CHAPEL VIEW

SEWAGE DISPOSAL TESTING

MARYLAND STATE DEPARTMENT OF HEALTH

HOWARD COUNTY

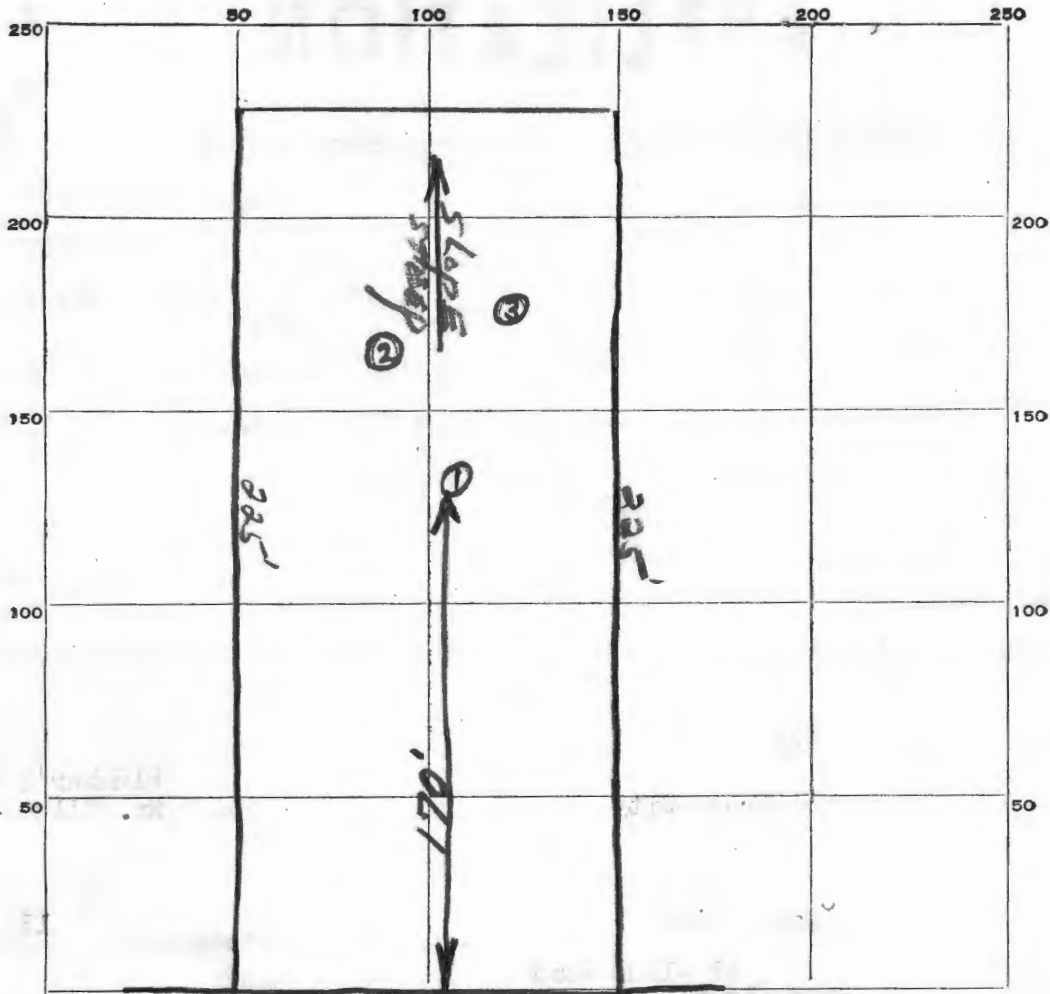
564 sq. FT. of tile field located 470 ft. from the front property line. Trenches to run across slope and have grade of one inch fall on tiles for every 33 ft. of trench.

75 gal. septic Tank.

SOIL AUGER FINDING _____
 TESTED BY J. Herring
 REMARKS Maintain 1" fill on tile in trenches for every 33'
 11-1-61
 ALSO PRESENT Ralph Klein LOT NO. 12

Public sewer on adjacent lot ends approx. 25' from
subject property line (manhole 10' deep)

need elevation of house to be built

9-14-68. Mr. Johnson said their surveyor is to shoot
elevations from lot to sewer on adjacent lot. F.F.

APPROVED BY J. Hennigan FOR Tile field DATE 11-1-61

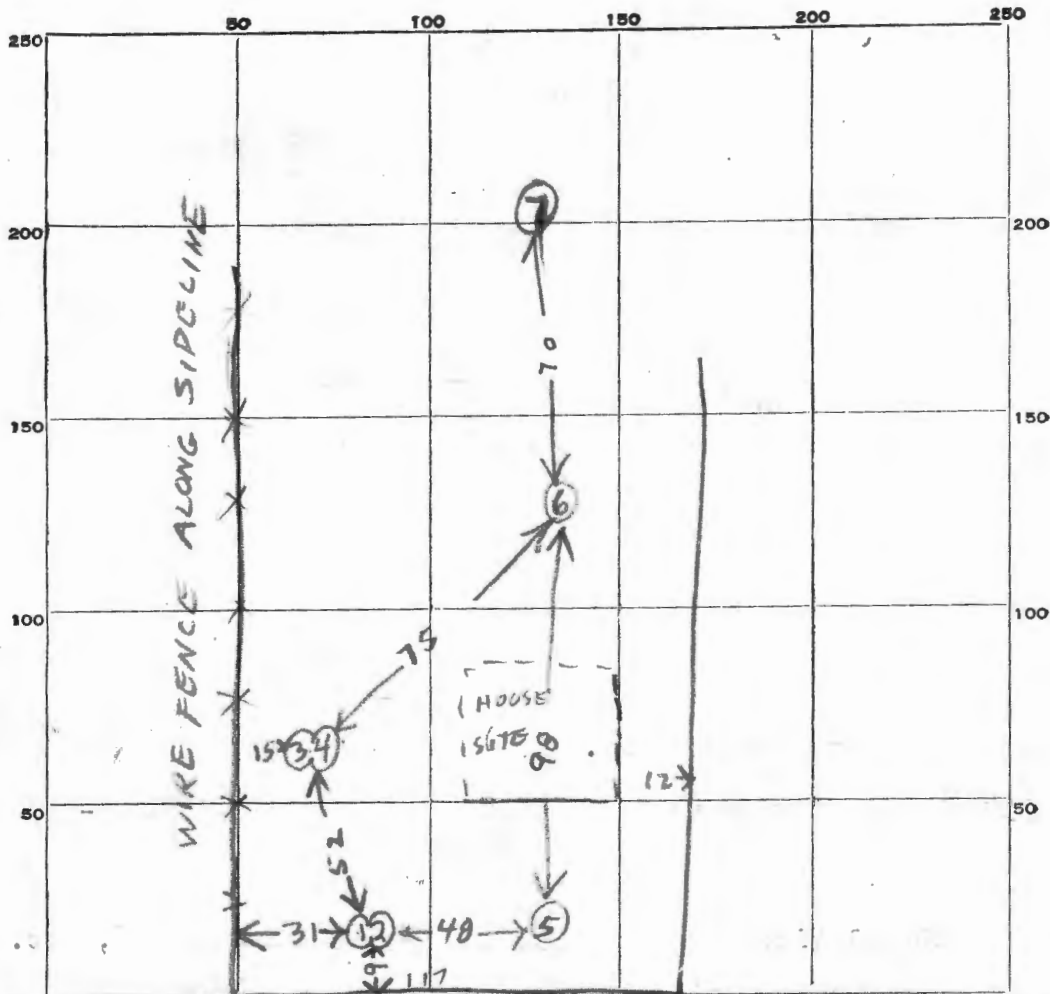
*1000 gallon tank
Leaching Bed - 850 sq ft bottom
area installed at a depth of 5 ft*

*Place the bed ^{between} 10 ft & 40 ft from the
front lot line and ^{between} 10 ft & 40 ft from the
left side of the lot as seen when ~~viewed~~
facing the lot from
Chapel View Drive*

APPROVED BY Raymond Hodges FOR Leaching Bed DATE 14 OCT 64
(KIND OF SYSTEM)
